**Approval of “BLAU” Sensor Flush Valve  
(General Acceptance No. ZC20250603F)**

**Details of Fitting:**            1" Sensor flush valve for WC

**Model:**                          BQ15

BQ15

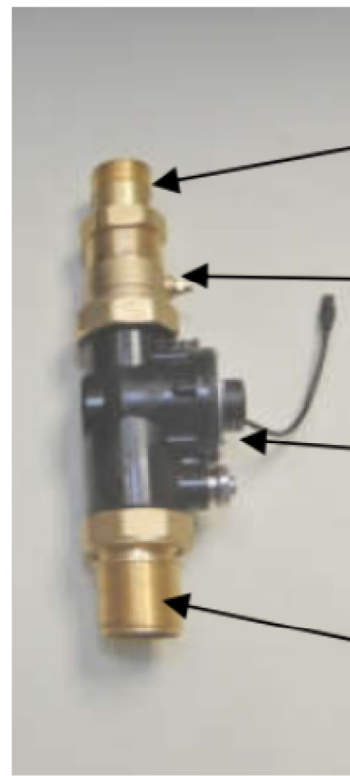
As the fitting has not been tested for use in contact with water intended for human consumption, the fitting can only be used in flushing water plumbing systems.

"Installation of filter before flushing valve is required. Without the filter, the flushing valve is liable to leak. The installed filter need frequent inspection and cleaning to maintain flushing supply. Normally only public toilets with good management system for maintenance would be considered."

"A stop cock or gate valve must be installed at the upstream of the fitting for manual isolation of water supply."

"The design flushing volume of the flushing valve should be compatible with the toilet bowl to ensure that effective clearance can be achieved by a single flush of water."

"Flushing valve should be used within the range of working pressures specified by the manufacturer." AND

"Installation of electronic opening and closing sanitary tapware should also comply with the requirements of Electrical & Mechanical Services Department."

This Authority hereby permits the use of the above fitting in flushing water plumbing systems subject to full adherence to Waterworks installation requirements. In particular, you are required to draw your customers' attention to the following requirement-
